Re: **Pacific Seafood – Mukilteo Facility**
Request for Additional Information
Project Number 2160231.00

In response to your request for additional information dated December 22, 2015, we have addressed the items below, with our responses following your comments.

PACIFIC SEAFOOD
PROCESSING FACILITY
8007 44TH AVE W
MUKL TEO, WA 98274
DRAINAGE PLAN

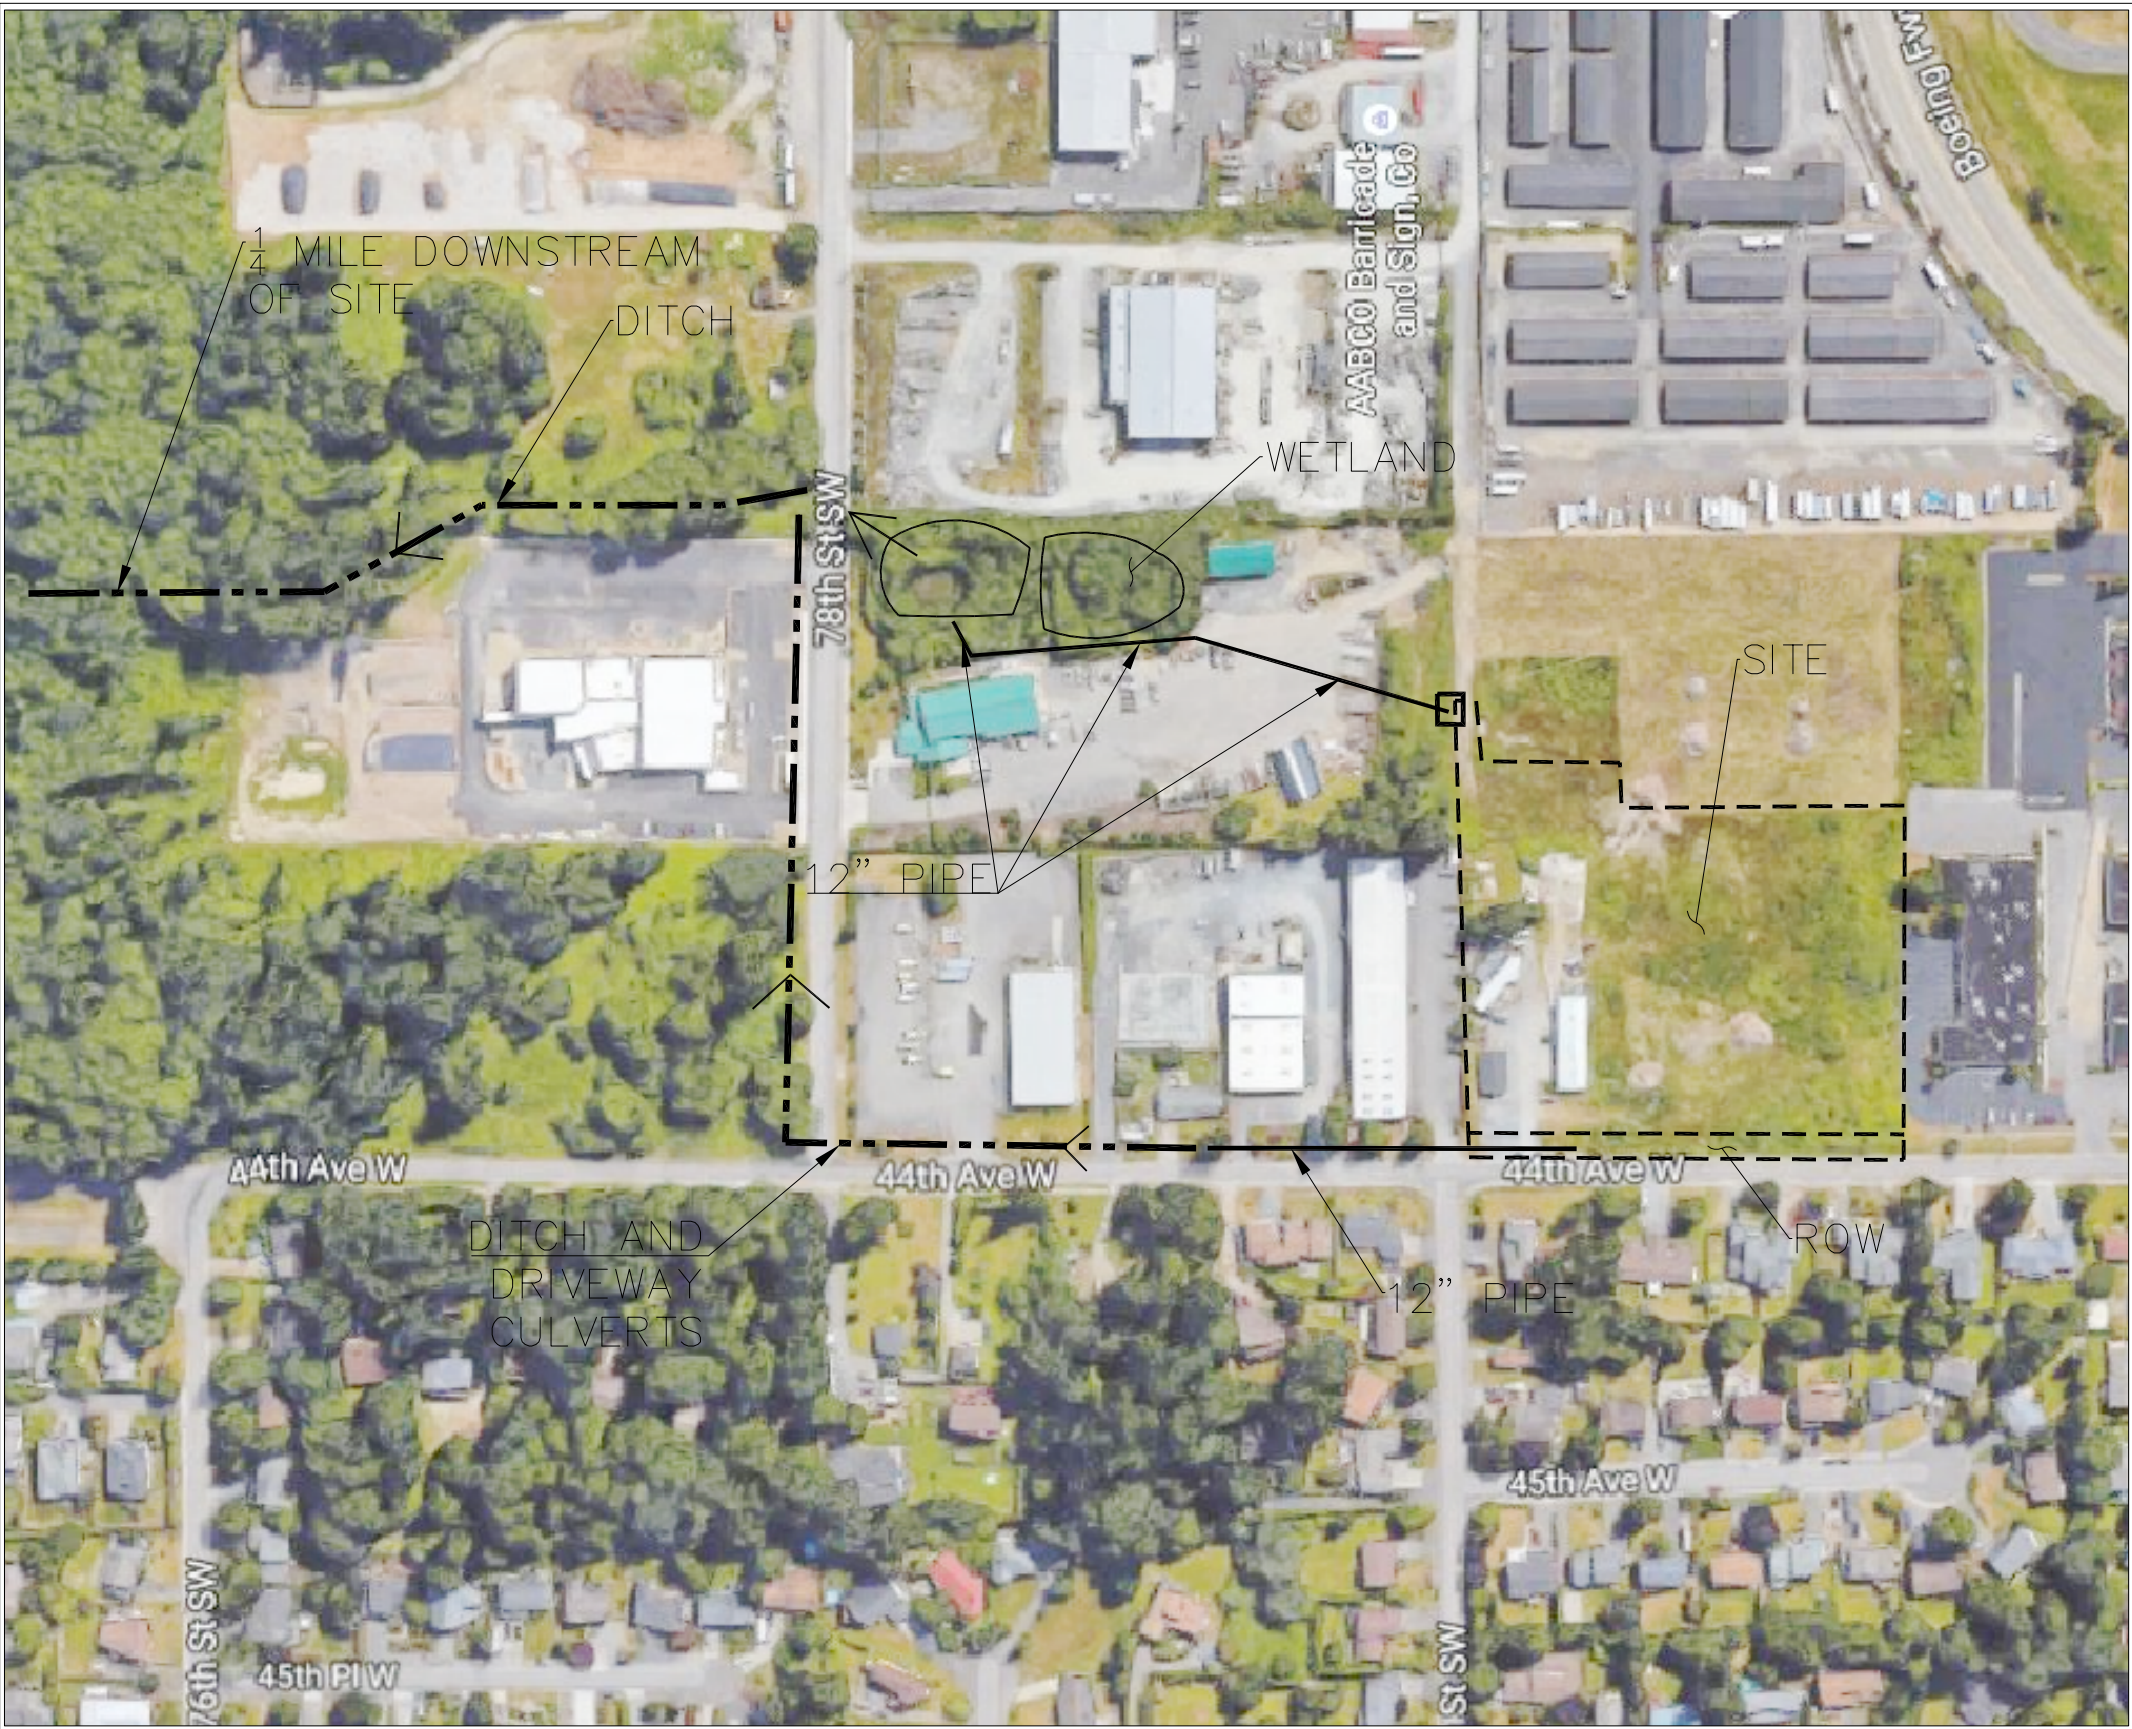
10. *Sheet C-2.0:*

- a. *A portion of the stormwater discharge pipe is not on the property (See General Note #3 above). Provide evidence of easement for the proposed stormwater pipe location.*
- b. *Some areas of the site appear to bypass the proposed detention system. Provide evidence that all runoff is treated according to the Minimum Requirements*
- c. *Roof drain tie-ins to the stormwater system need to be shown.*

Response: The storm drainage pipe has been relocated to the existing easement established for this storm outfall pipe. The stormwater system has also been revised for the new site plan, and runoff is treated in accordance with minimum requirements. Roof drain tie-ins are shown on the drainage plan, Sheet C-2.0.
